Fashion Asia Ltd. (New Unit)

3rd December 2020

Observations

Plastic water tanks on roof top

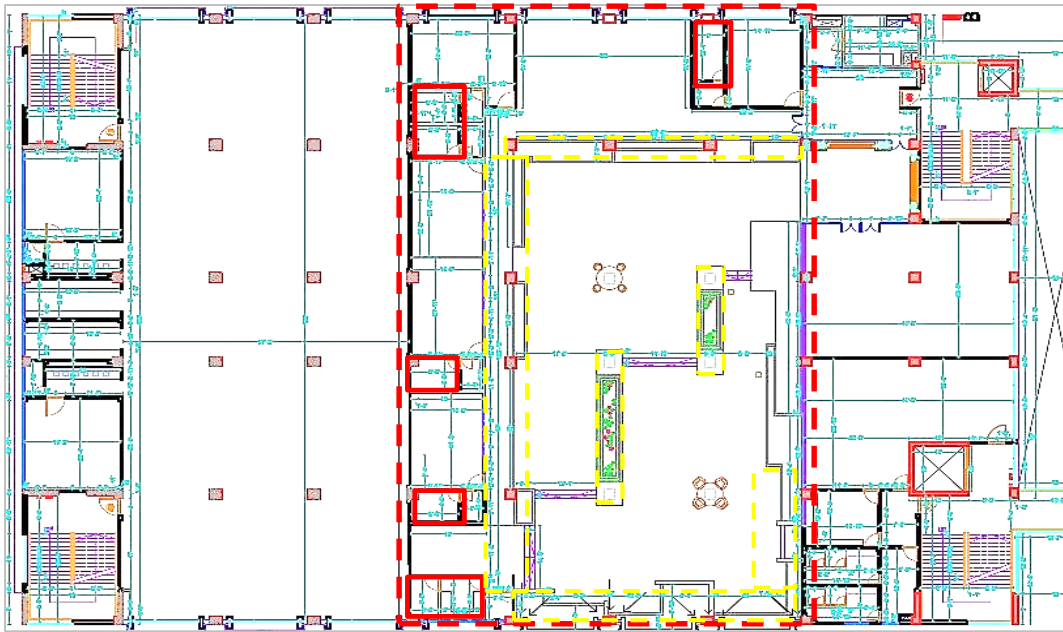
There are five 10,000 liters and one 5,000 liters plastic water tanks on roof top. There are 190 mm built up beneath all the water tanks. But these are not included in the provided As-built drawings and load plan.

Variable flower bed and built up areas in toilet areas on 4th floor

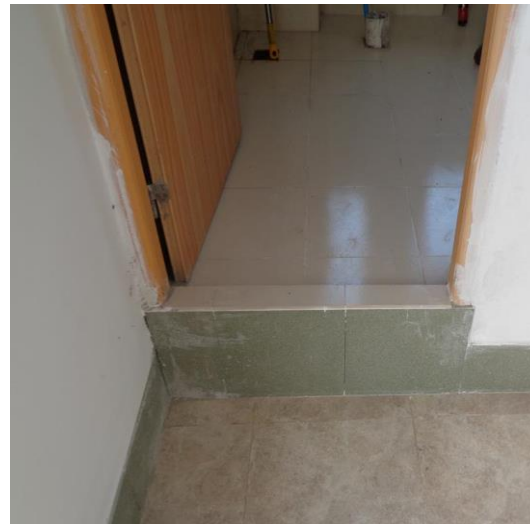
4th floor central area is being decorated with flower beds of variable heights (300~400 mm). Also, toilet areas have variable built-ups (190~240 mm). These built-up areas are not included in the provided as-built drawings.

No design report was available for Production Building

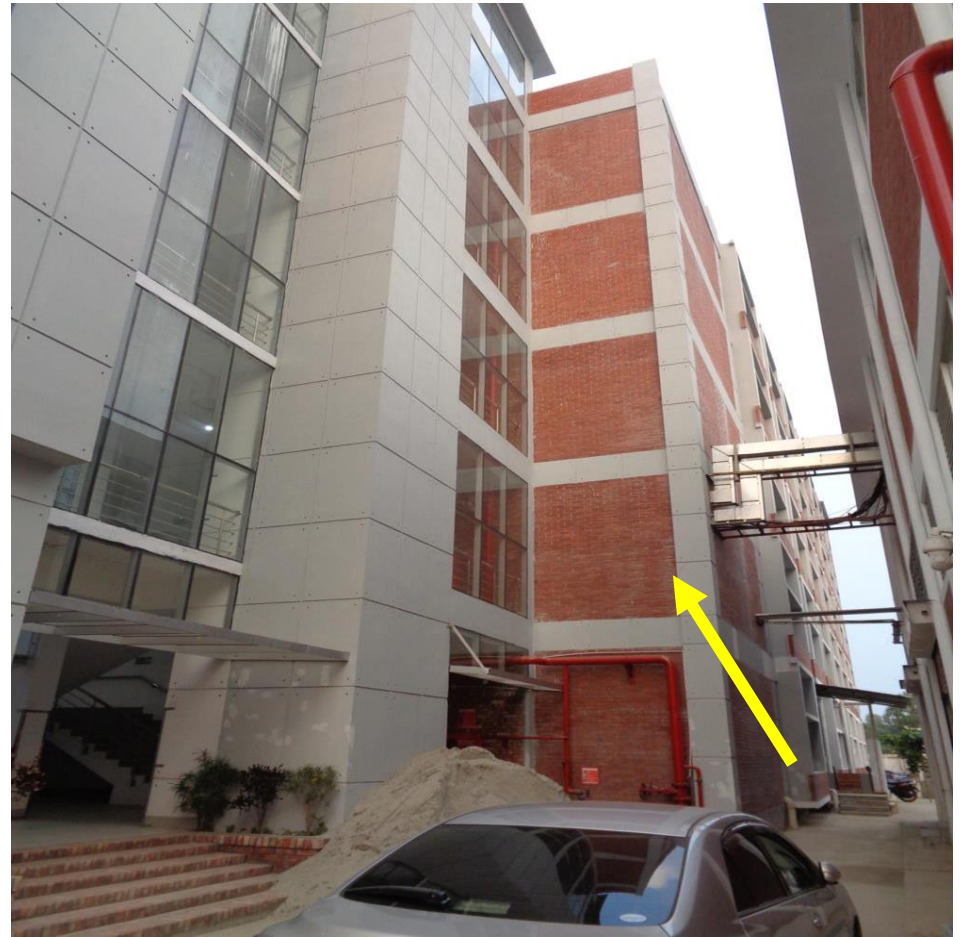
As per BNBC, every building or structure designed shall have its design documents prepared in accordance with the provision of Section 1.9.1. The design document shall include a design report, and a set of structural drawings, which shall be prepared in compliance with section 1.9.1.1 and section 1.9.1.2 as per BNBC. At the time of inspection, only as-built drawing, load plan and geotechnical report were available, but no design report was available which is required to be prepared in compliance with section 1.9.1.1 (part-6, BNBC).

Two cantilevers are separated by a joint but filled with rigid materials at top

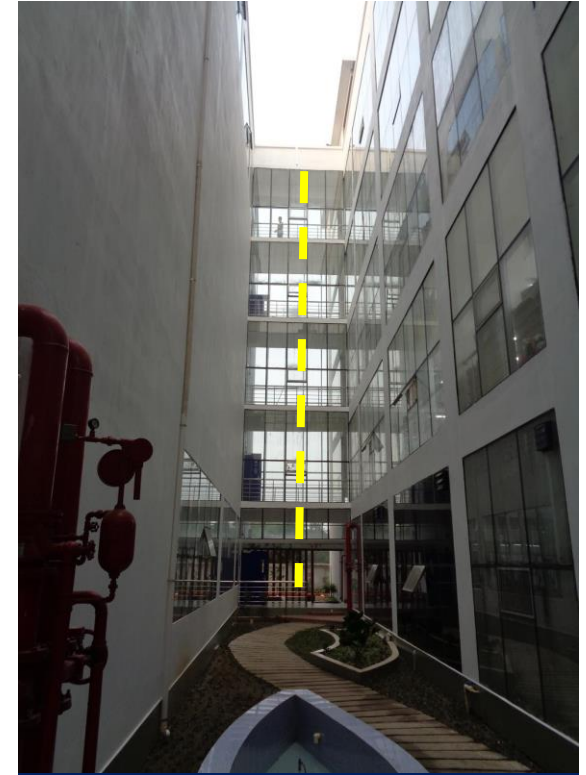
Warehouse Building and Production Building Both are cantilevered at north and south side which are being used as a walkway are separated by a movement joint. However, the joint is filled with rigid material at top which may obstruct the building movement and crack may be developed. Factory is required to fill the joint with any flexible material suggested by the factory consultant.

No Design report was available in the factory site for Amenities Building

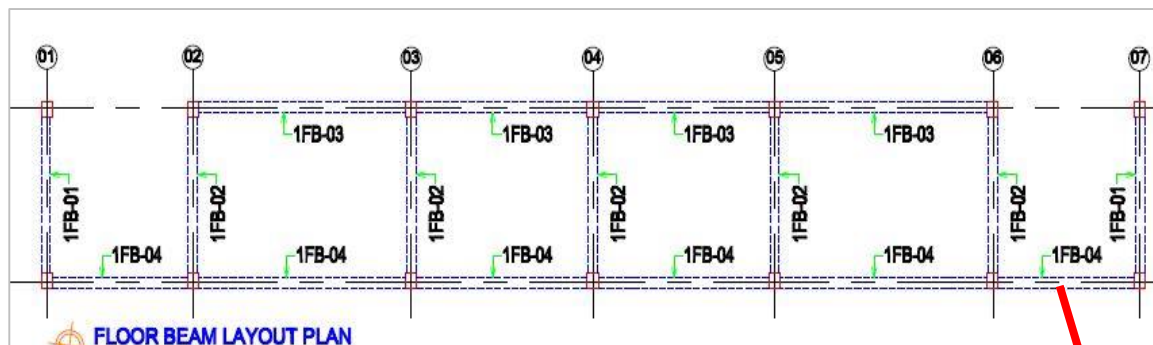
As per BNBC, every building or structure designed shall have its design documents prepared in accordance with the provision of Section 1.9.1. The design document shall include a design report, and a set of structural drawings, which shall be prepared in compliance with section 1.9.1.1 and section 1.9.1.2 as per BNBC. At the time of inspection, only as-built drawing and geotechnical report were available but no design report was available which is required to be prepared in compliance with section 1.9.1.1 (part-6, BNBC).

Beam layout of Amenities building

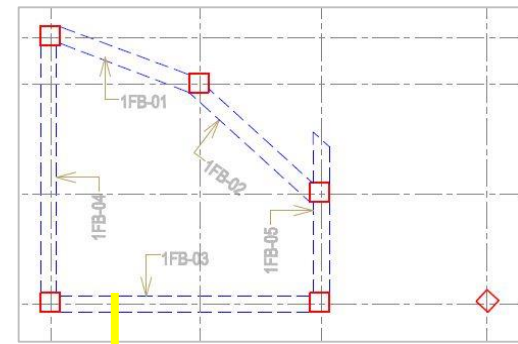
As-built structural drawing of Amenities Building and security-2 are produced separately but in reality two Buildings are found as one building and structurally connected. Factory is required to update the as-built structural drawing and prepare design report as a whole.
